## REVISED RESPONSE TO REQUEST FOR ADDITIONAL INFORMATION

### APR1400 Design Certification

Docket No. 52-046

RAI No.: 207-8247  
SRP Section: 12.02 – Radiation Sources  
Application Section: 12.2  
Date of RAI Issue: 09/11/2015

**Figure 1 MCR Charcoal Filter Shine Geometric Shielding Model**

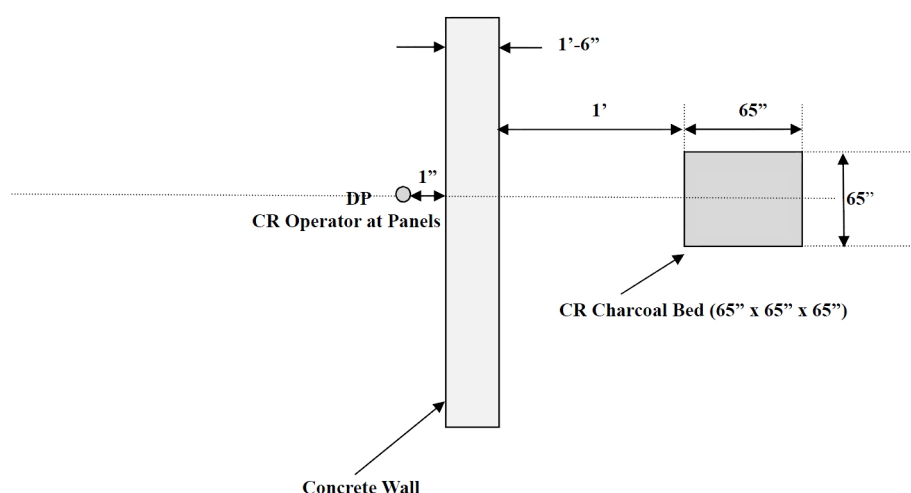
3. Update the FSAR to provide radioactive source dimensions and parameters for major post-accident source term components such as the shutdown cooling pumps and accident emergency control room ventilation filters and identify the locations of these components.

Dimensions for the MCR filter is provided in DCD Table 15.6-13 (3 of 3). The geometric model for the MCR charcoal filter shine dose calculation is shown in Figure 1. This model is based on the location of the MCR ACU and surrounding concrete shielding. In the shielding analysis, the charcoal tray of height 1.65 m is conservatively used.
